Technical Service Information

CHRYSLER A604 DELAYED REVERSE ENGAGEMENT

Figure 1

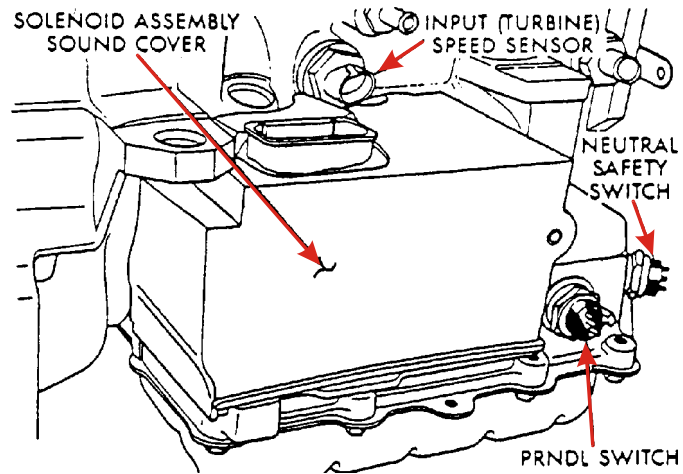
CAUSE: NUMBER ONE - The cause may be, a defective PRNODL Switch located in the case (See Figure 1 for Location), because of no signal to the controller that reverse was selected.

Figure 2

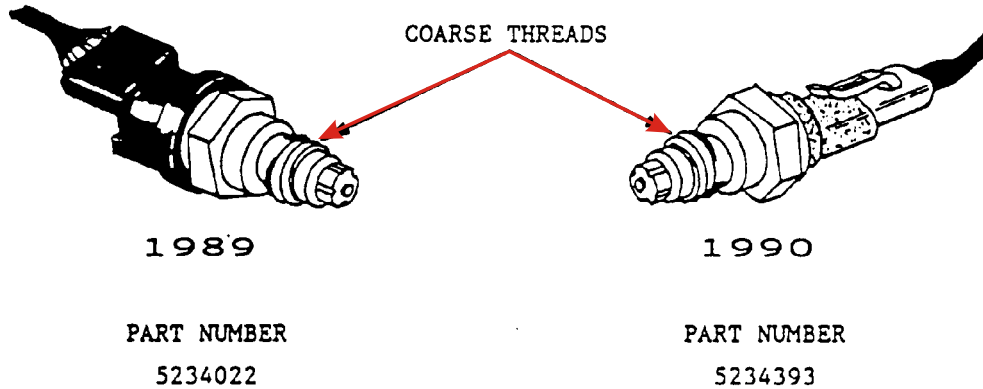
CORRECTION: NUMBER ONE - Replace the PRNODL Switch located in the case with the appropriate OEM part number (See Figure 2).

THESE PRNDL SWITCHES WILL NOT INTERCHANGE.

Figure 3
AUTOMATIC TRANSMISSION SERVICE GROUP

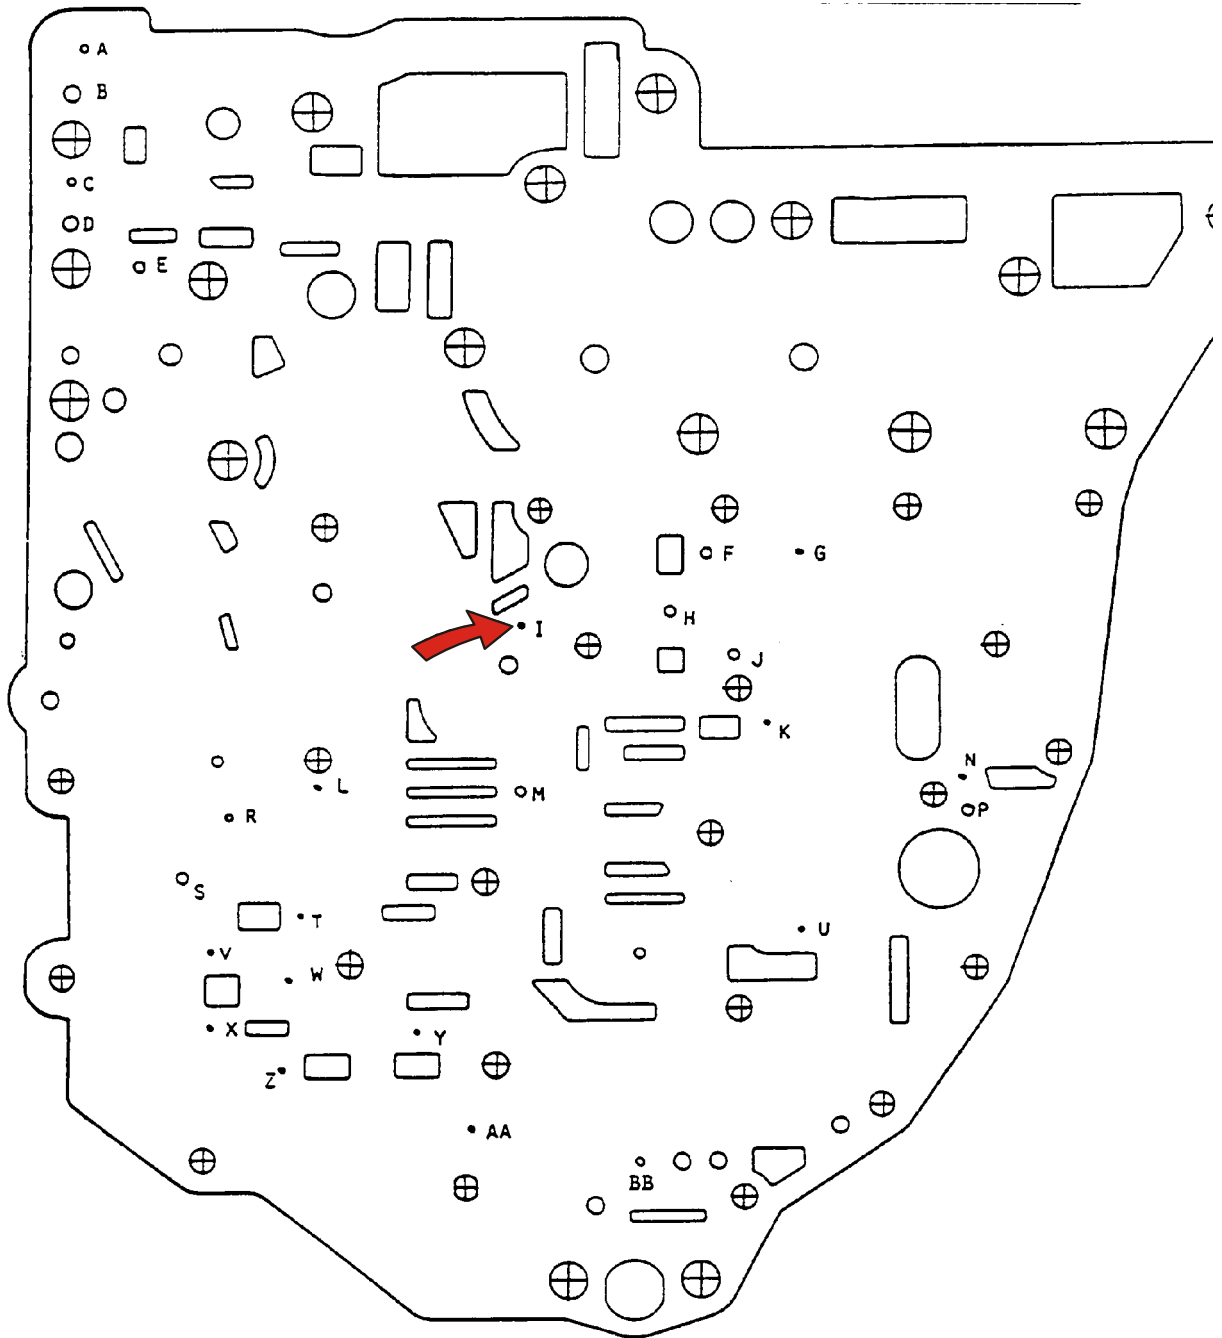
NUMBER TWO - The cause may be, not enough reverse oil flow through the orifice to the reverse clutch.

NUMBER TWO - If the condition still exists after checking, or replacing the PRNODL Switch, drill the hole in spacer plate marked "I", as shown in Figure 3.

DRILL HOLE MARKED "I" TO .093" AS SHOWN ABOVE
